UNITED STATES
DEPARTMENT OF THE INTERIOR
BUREAU OF LAND MANAGEMENT
SUNDRY NOTICES AND REPORTS ON WELLS

5. Lease Serial No.	NM-012121
6. If Indian, Allottee or Tribe Name	
7. Unit or CA Agreement Name and No.	
8. Well Name and No.	Cotton Draw 26 Federal 3H
9. API Well No.	30-015-37404
10. Field and Pool, or Exploratory	Poker Lake South; Delaware
11. County or Parish State	Eddy NM

**Cotton Draw 26 Federal 3H
30-015-37404
Devon Energy
March 12, 2010
Conditions of Approval**

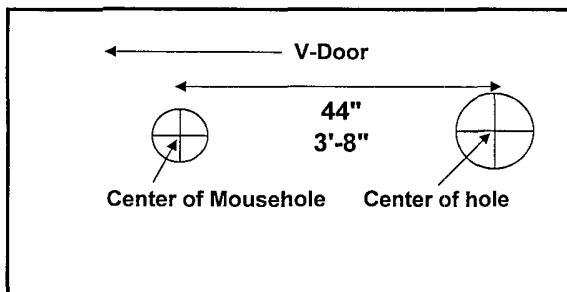
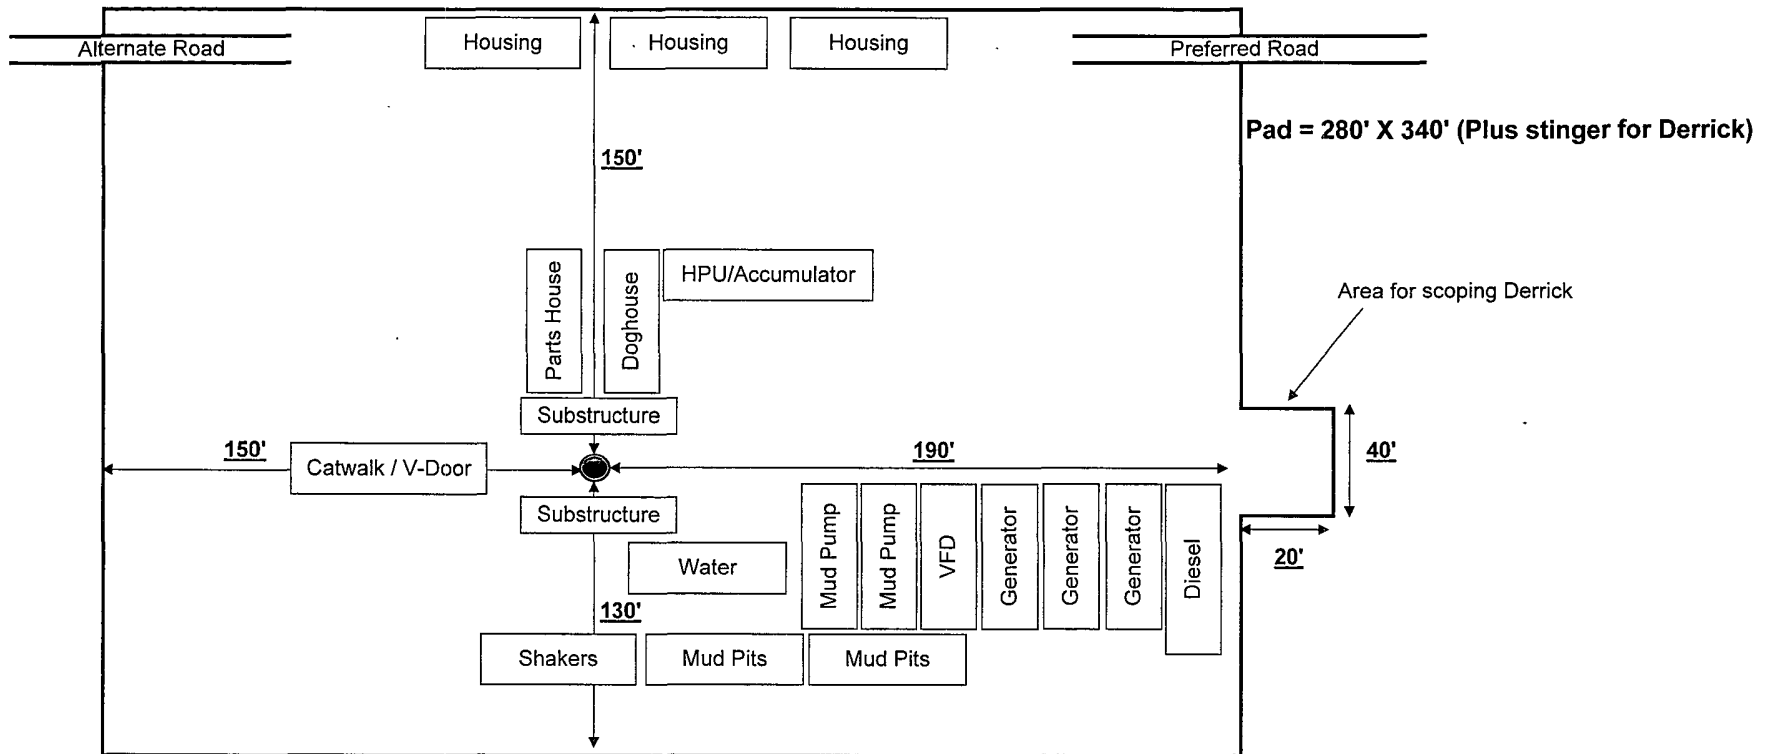
Devon Energy Production Company L.P. respectfully requests to change the rig layout from the McVay #8 to the H & P #212 to drill this well and requests a variance that a co-flex hose may be used between the BOP and the choke manifold. The hose will be kept as straight as possible with minimal turns. CO-Flex Hose Manufacturer: Phoenix Beattie; ~ 33' (11.43 meters) of co-flex line; 3" coupling w/ 4 1/16" flange on each end - 10,000 psi; Quality Control Inspection & Test Certificate attached; see configuration schematic. Safety clamps are not required since the ends are flanged.

1. **Variance approved to use flex line from BOP to choke manifold. Check condition of 3" flexible line from BOP to choke manifold, replace if exterior is damaged or if line fails test. Line to be as straight as possible with no hard bends.**
